Re: Office Warehouse for McClintic RDM 9700 Trumbull, Traffic Circulation Layout
Engineer's Stamp dated 6-17-14 (L20-D051)

**SUBJECT: TRAFFIC CIRCULATION LAYOUT
OFFICE WAREHOUSE FOR McCLINTIC RDM (L20-D051)**
9700 Trumbull Avenue SE
Albuquerque, New Mexico 87123

As agent for McClintic RDM, we hereby submit for review and approval 2 copies of the revised Traffic Circulation Layout for the subject project. The comments listed in the May 28, 2014 letter issued by Cynthia Beck have been addressed as follows:

SITE PLAN

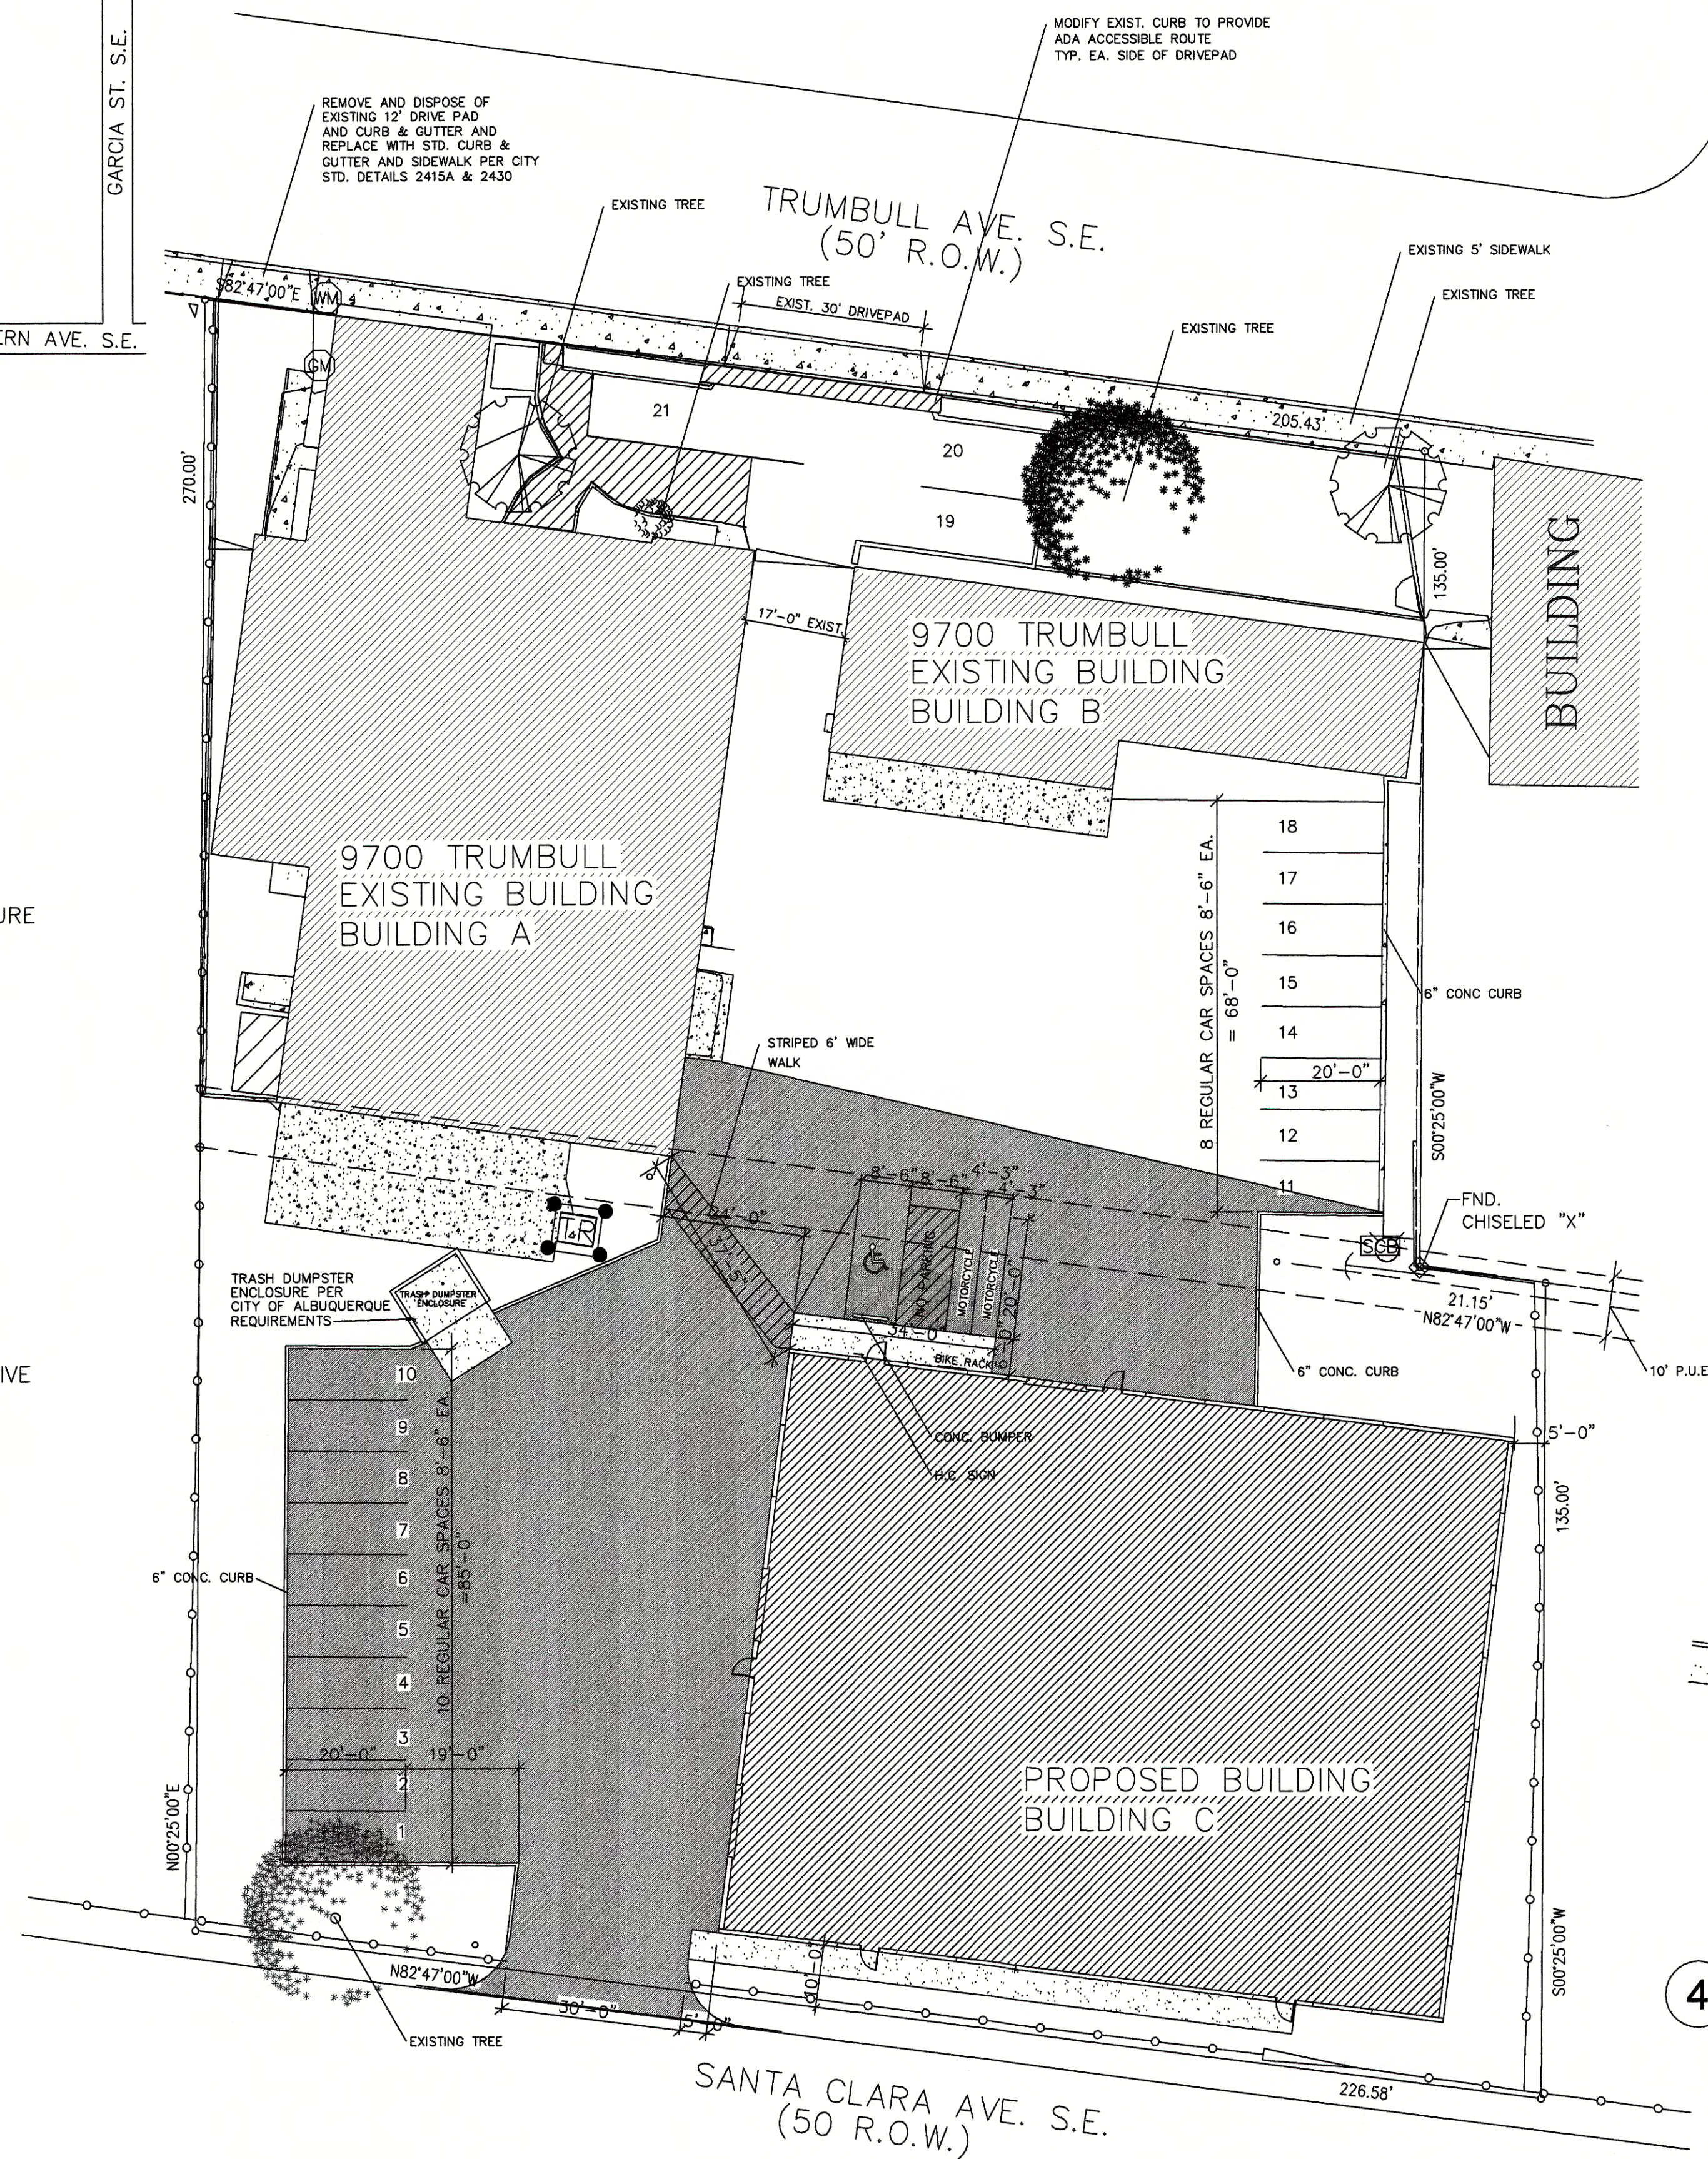
1. The Plan is in compliance with DPM and ADA standards.
2. Applicable City standards are referenced where necessary.
3. The proposed 6-foot wide pedestrian way has been modified to connect the new building entry to the rear entry of existing Building "A". A striped pedestrian link is also provided from the existing front entry of Building "A" to Trumbull.

4. The distance between Buildings "A" and "B" is dimensioned.
5. The project entry will be modified to provide ADA accessibility per DPM. Detail 4 is provided to detail a 3-foot wide ADA pedestrian path around the existing driveway, within a 4-foot wide public sidewalk easement.
